**City of Portland, Maine - Building or Use Permit Application**

Location of Construction: 218 WASHINGTON AVE	Owner Name: MORSE GLENN A	Owner Address: PO BOX 1466	Phone:
Business Name:	Contractor Name: Morse Construction/ Glenn Morse	Contractor Address: P.O. Bos 1466 Scarborough	Phone 2075903877
Lessee/Buyer's Name	Phone:	Permit Type: Additions - Commercial	Zone: B-1b

CHECK-LIST AGAINST ZONING ORDINANCE

**RE: Site Plan Review; 218 Washington Avenue  
Four Residential Condominiums  
Application # 2008-0032; CBL 010 A015001**

SITE SKETCH PLAN

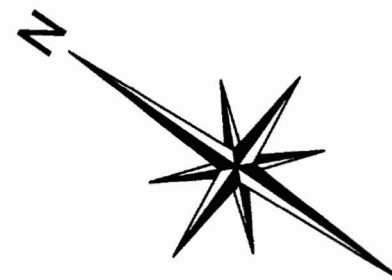
9. The plan shows a steep slope behind the structure, which was created with fill. Please provide a geotechnical report for the slope and long-term stability and maintenance of the slope.

14. It is indicated that the stormwater will sheet flow off this parcel. As discussed at our meeting, a stormwater management report must be included as part of the application for review by the City's third-party review engineer.

SITE SKETCH PLAN  
**GLENN MORSE**  
**218 WASHINGTON AVE.**  
 PORTLAND  
 MAINE

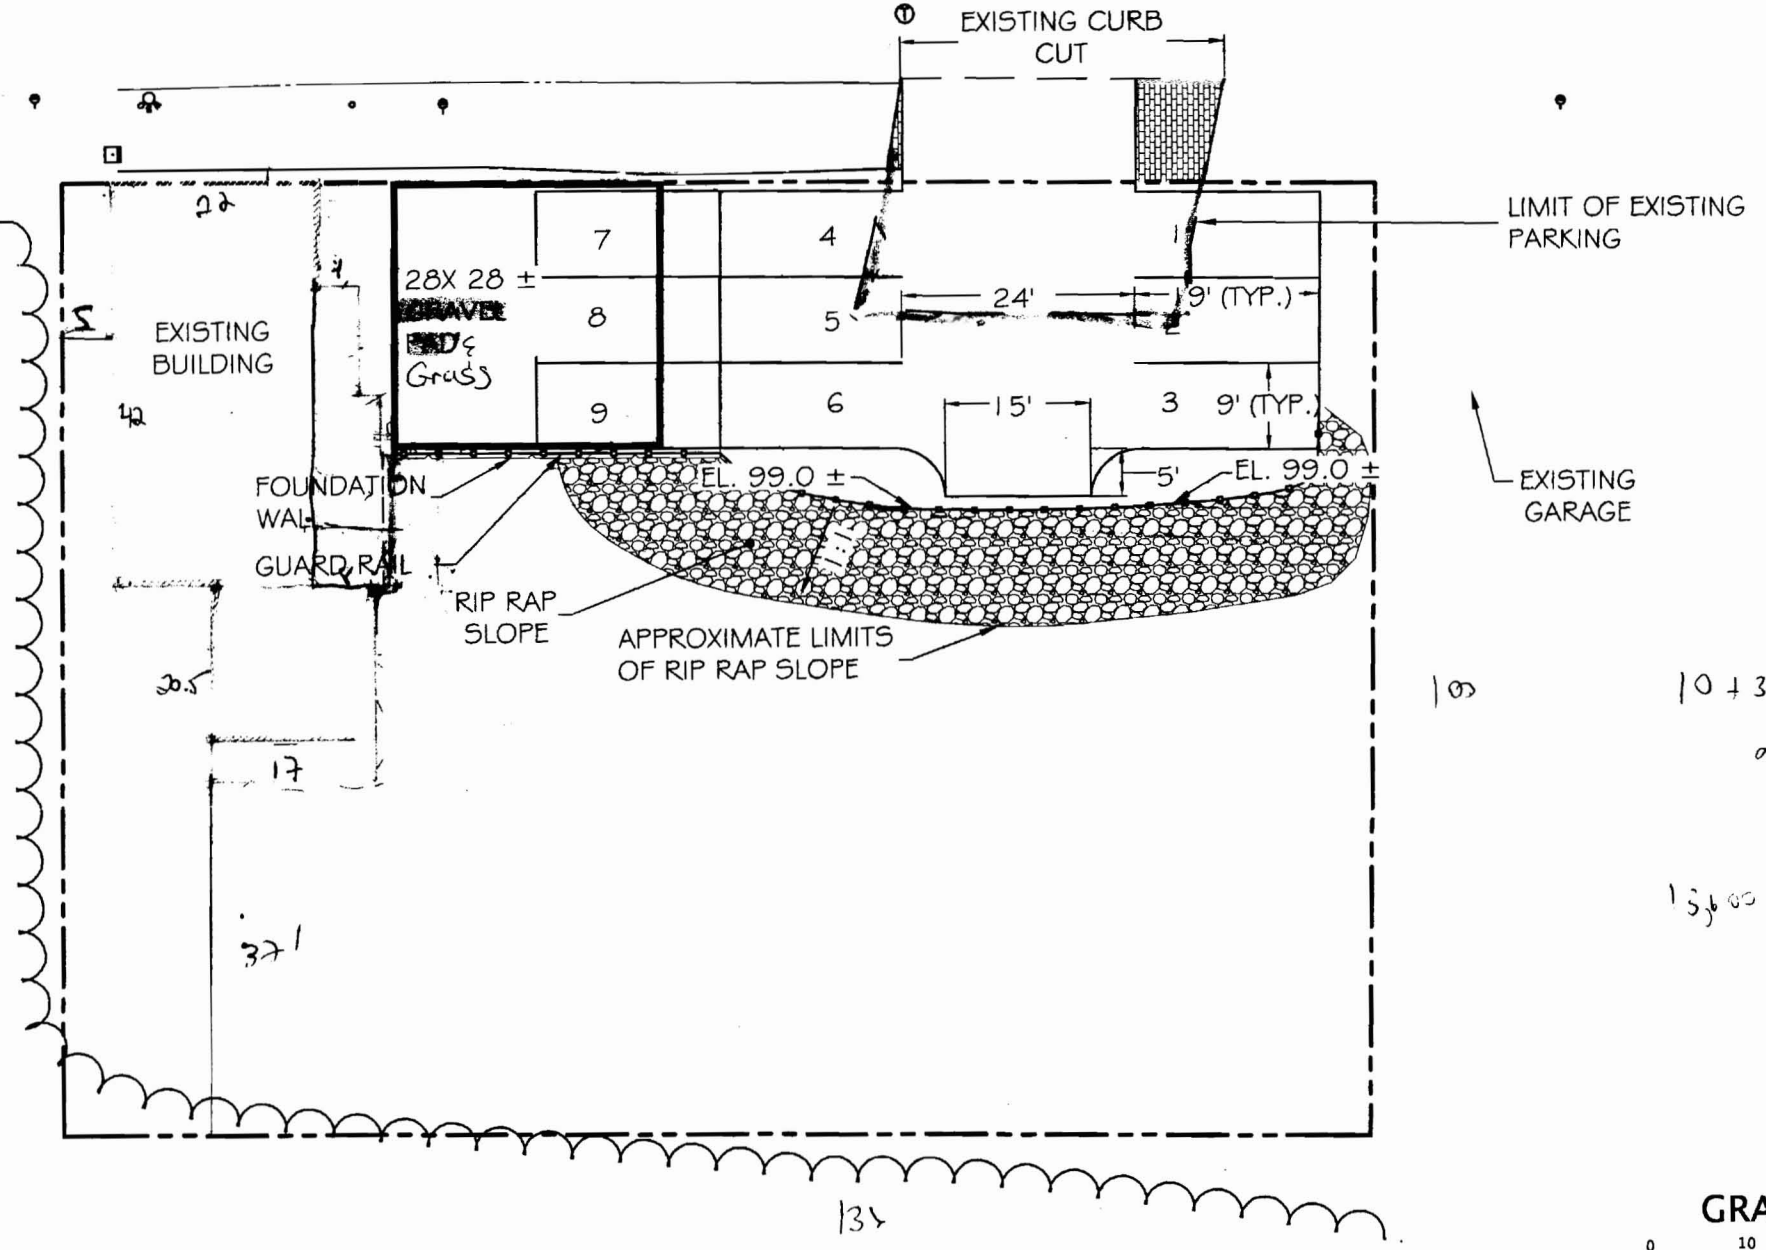
- ① need to know which is 1st floor - do or grade?  
- need to see floor to ceiling height in relation to grade
- ② need elevations to show grade
- ③ ~~need site plan that shows whole property~~ SF. of site plan not match  
assessing - ? came up w/  
meeting w/ Shukria
